Missing Mars probes

Screaming Circuits

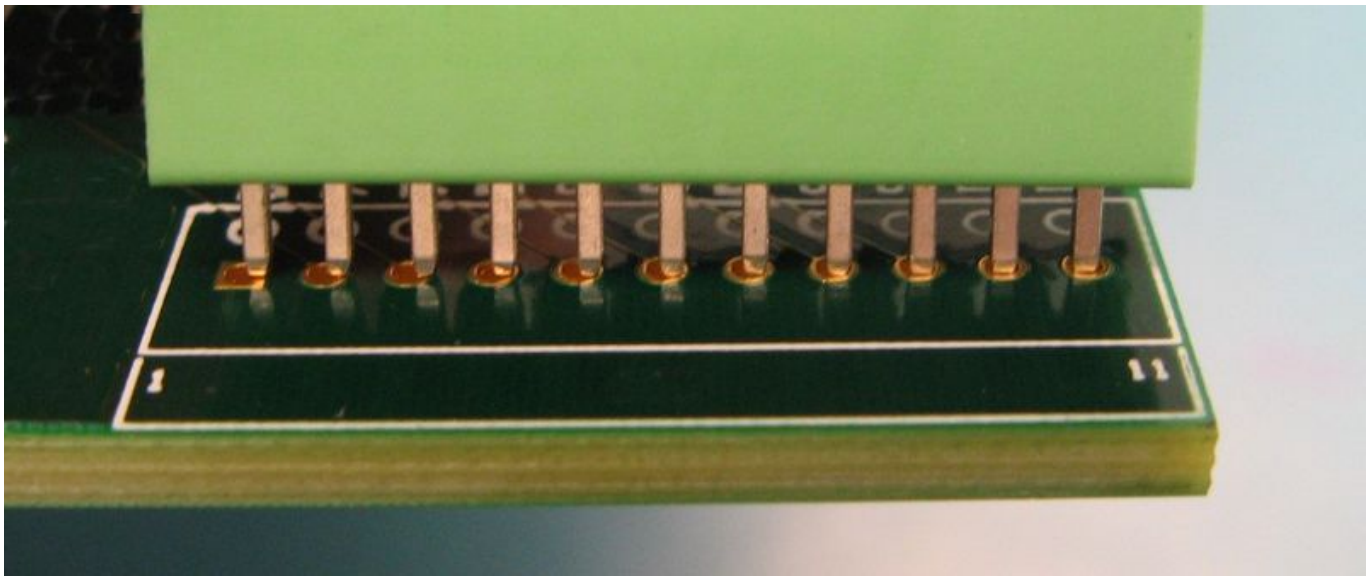
This seems to pop up most often with connectors, as in this image, but it occasionally shows up on other types of parts as well. The footprint here is for a .1" (2.54mm) pitch connector. The connector has 2.5mm pitch. It would be fine for three pins, maybe four or five. But beyond that, it's just not going to fit.

I don't really understand the logic in 2.5mm pitch. If .1", which equals 2.54mm weren't such a ubiquitous standard, 2.5mm would make sense, but as it is, it's just too close. It's close, but they aren't the same. 2.5 != 2.54.
